**FINAL
INITIAL STUDY/
MITIGATED NEGATIVE DECLARATION**

**MONTEREY-SALINAS TRANSIT
MONTEREY BAY OPERATIONS AND MAINTENANCE FACILITY
RENOVATION AND EXPANSION PROJECT**

SCH #2015051004

July 6, 2015

CIVIL SITE PLAN
C-SD101

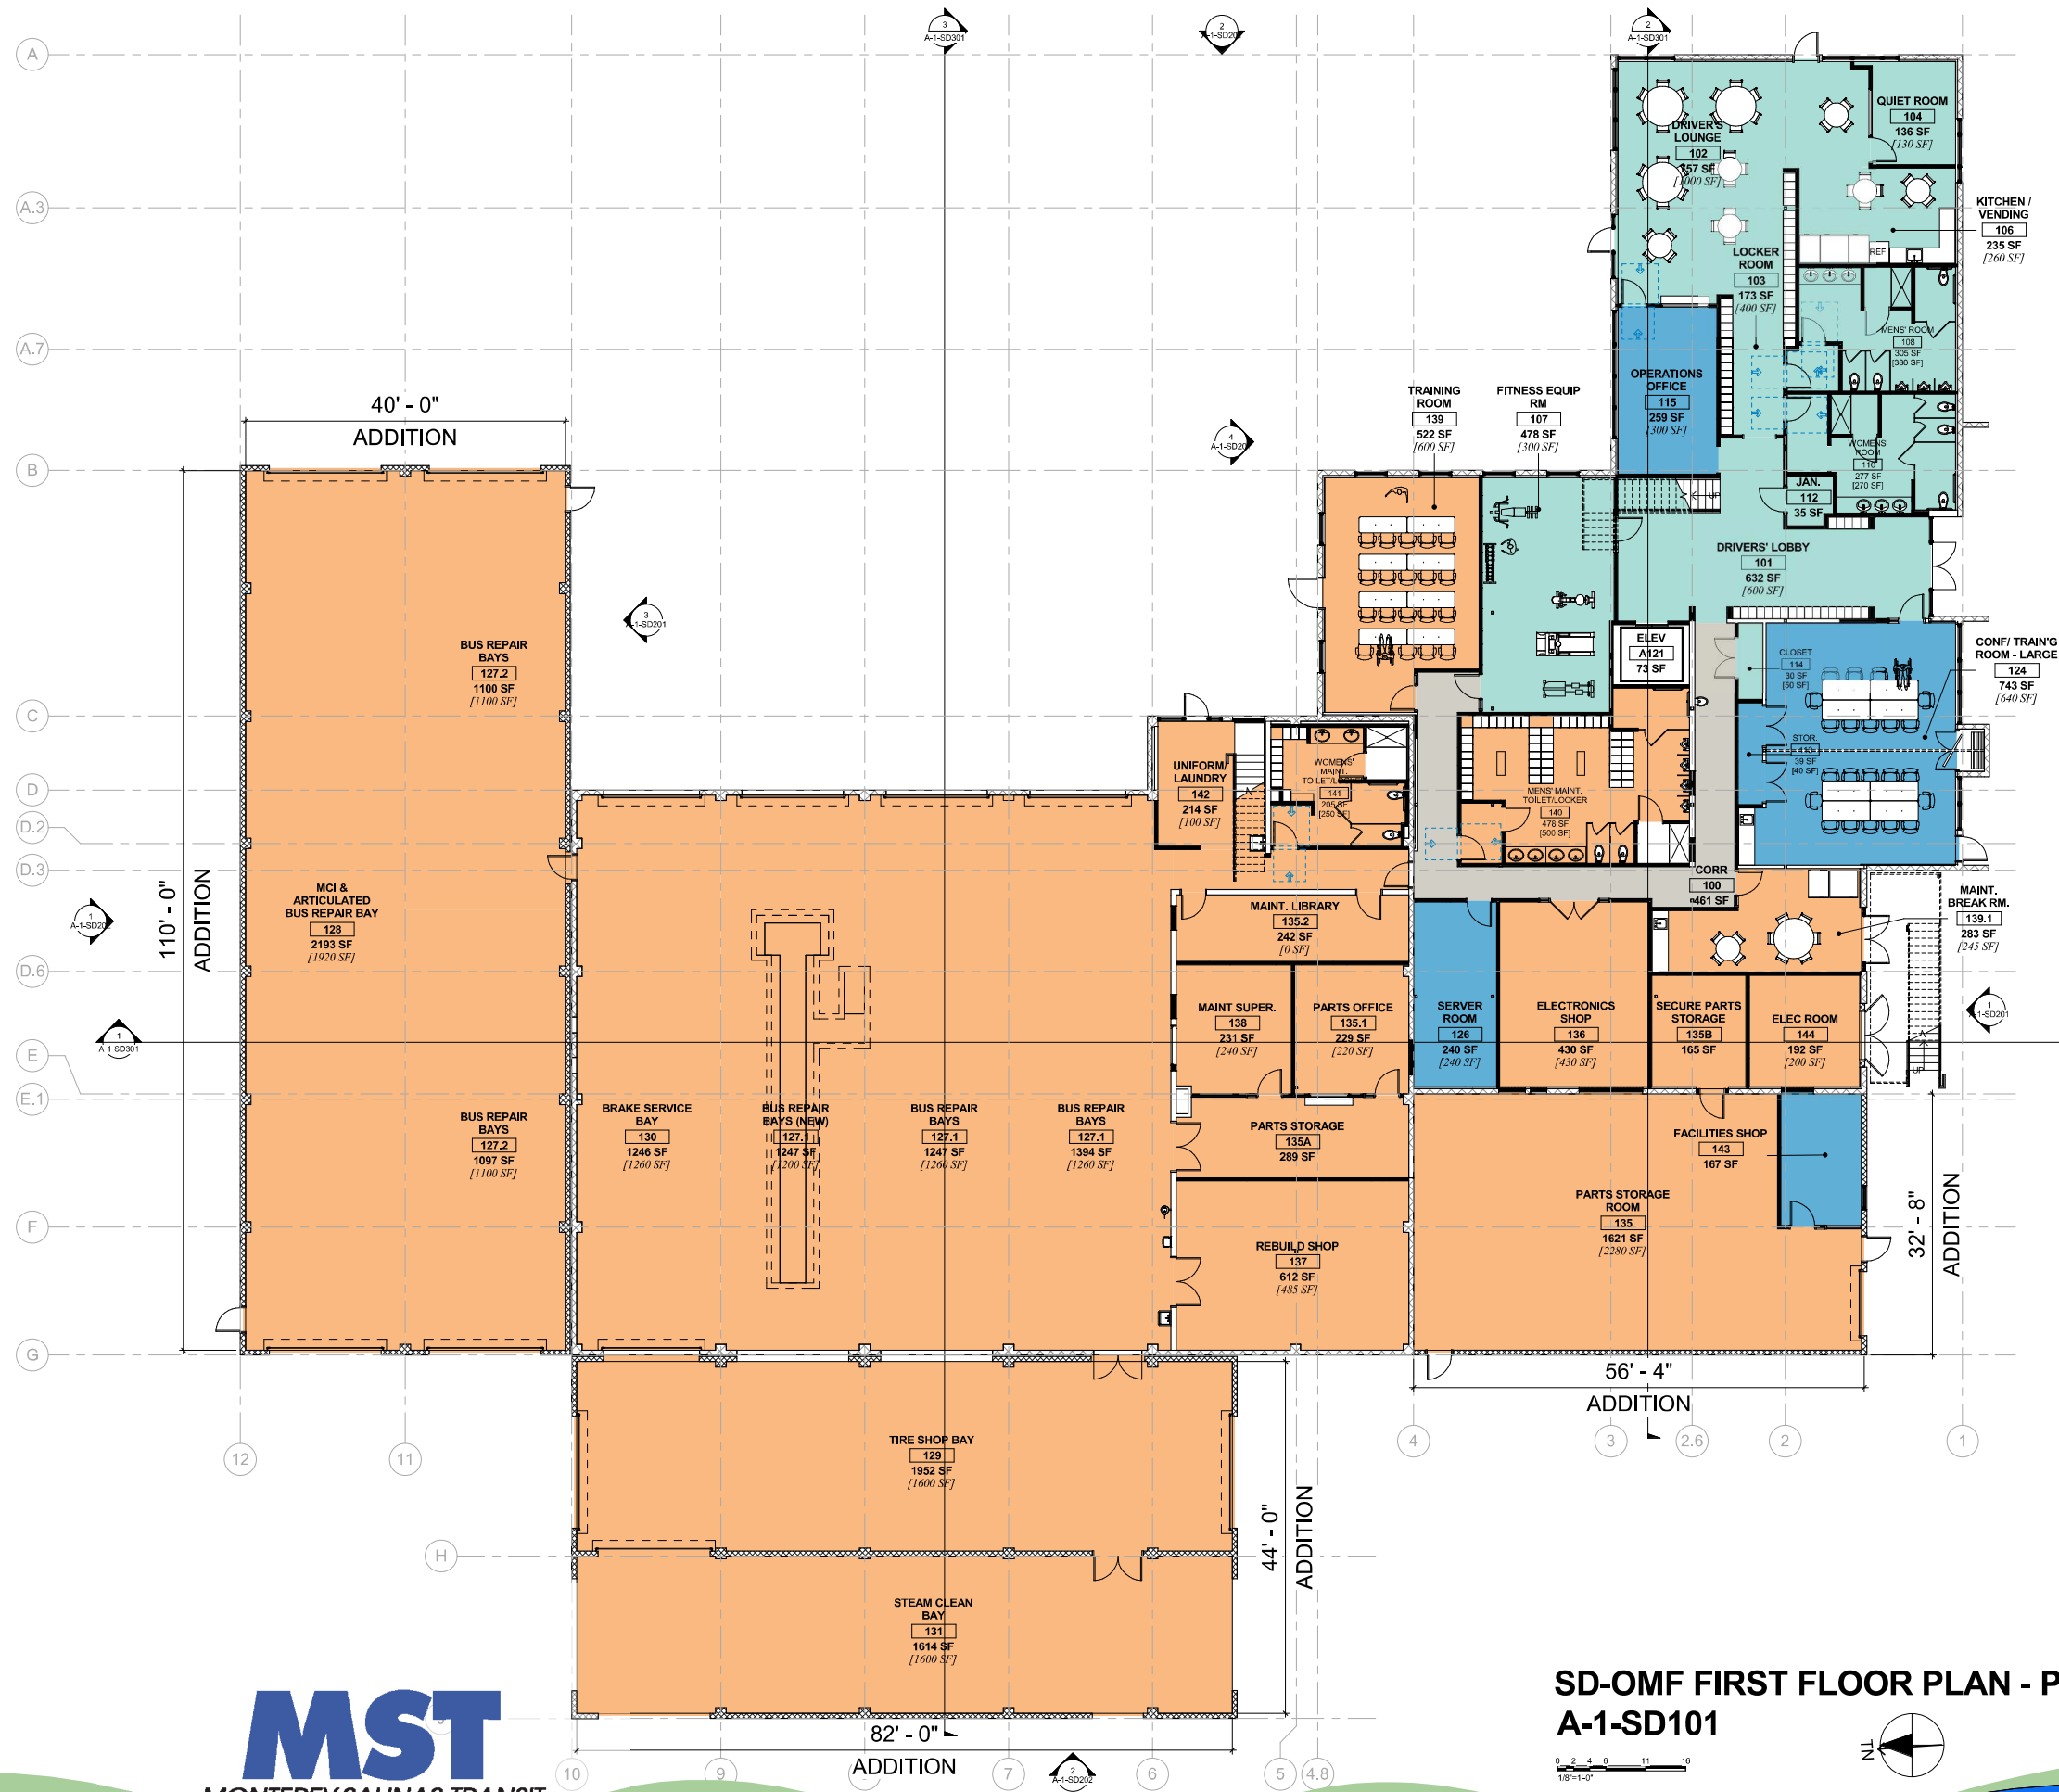
7. The City Traffic Division requests that the site plan be revised to show a pedestrian path of travel from the portion of the parking lot on City property to the facility. More emphasis is needed to resolve possible pedestrian access around the back of the building near the proposed additions. Safeguards should be added for pedestrians.

- C-7:** The bulb-out has been added at the southwest corner of the existing employee parking lot in order to minimize the length that pedestrians must travel to cross the entry drive. In addition, a sidewalk has been added in the bulb-out along with a striped crosswalk across the entry drive to encourage pedestrians to cross at the preferred location. Please refer to plan sheet C-SD101 in **Appendix B**.

A 6'-wide sidewalk has been added along the west face of the Parts Room, in order to keep buses exiting the Tire Shop from driving too close to the southwest corner of the Parts Room. Due to the very limited width available at the southwest corner of the Steam Clean Bay, openings have been added at the corner in order to provide line-of-sight

through the building. Please refer to plan sheets A-1-SD101 and C-SD101 in **Appendix B**.
